**Economic and Social Council**Distr.: General
20 July 2018

Economic Commission for Europe**Inland Transport Committee****World Forum for Harmonization of Vehicle Regulations****Working Party on General Safety Provisions****115th session**

Awareness of the proximity of Vulnerable Road Users:**New UN Regulation on Blind Spot Information Systems****Proposal for a new UN Regulation on uniform provisions concerning the approval of motor vehicles with regard to the Blind Spot Information System for the Detection of Bicycles****Submitted by the Informal Working Group on Awareness of Vulnerable Road Users proximity in low speed manoeuvres***

UN Regulation No. ~~XXX~~ECE/TRANS/WP.29/GRSG-2018-24e, amend to read:

Figure 1
Dynamic tests

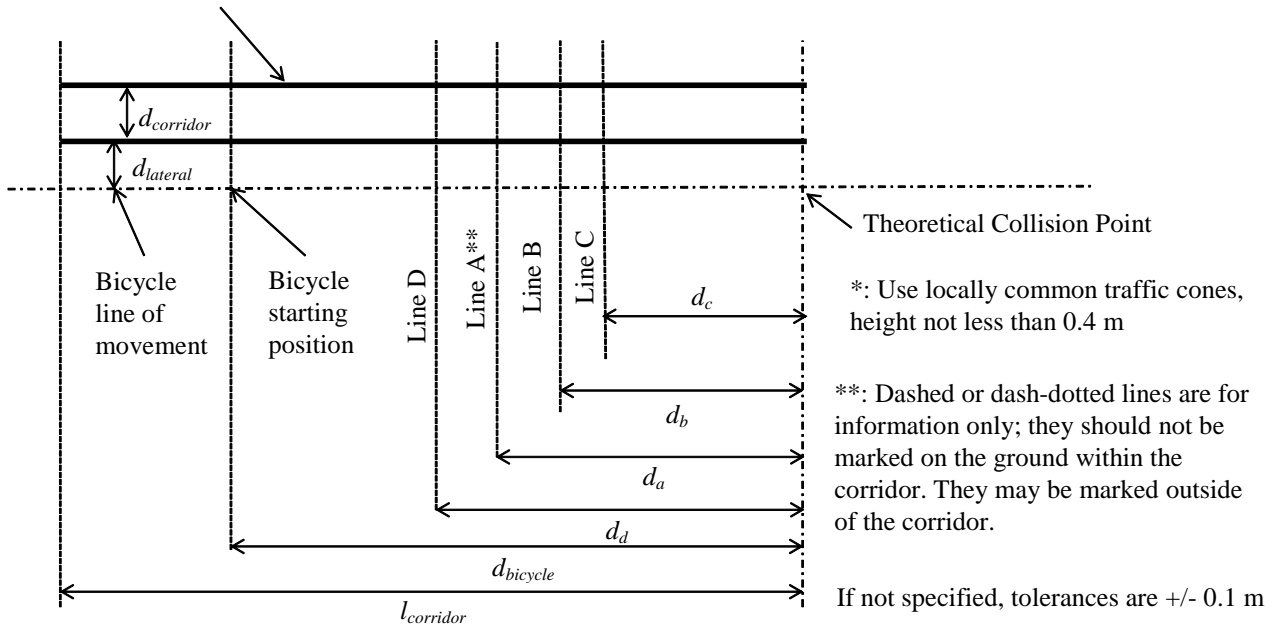
For vehicle speeds up to 5 km/h, it is deemed satisfactory if the information signal is activated 1.4 seconds before the bicycle has reached the theoretical

collision point as specified in Appendix 1, Figure 1. For vehicle speeds between 5 and 10 km/h, the value d_c shall be 5 m.

For vehicle speeds above 25 km/h, where the stopping distance is higher than 15 m, d_c as specified in Appendix 1, Figure 1 shall be as specified in Appendix 1, Table 2.

1. Small corrections made throughout the text for clarification.
 2. Modification of value d_c for tests performed outside of the test cases. Keeping value d_c at 15 m also for very low vehicle speeds leads to extraordinary high required sensor ranges that are not possible with today's technology.
 3. In particular, to take account of the potential sensor range limitations for test cases other than those specified in Table 1, the d_c -value has been fixed to 5 m for speeds greater than 5 km/h and below 10 km/h. This limits the required range to 30 m to the back, and the angle between truck edge and bicycle to values above 3°
 4. A new annex has been added to give guidance when calculating the performance criteria for test configurations other than the tests specified in Table 1, Appendix 1.
-
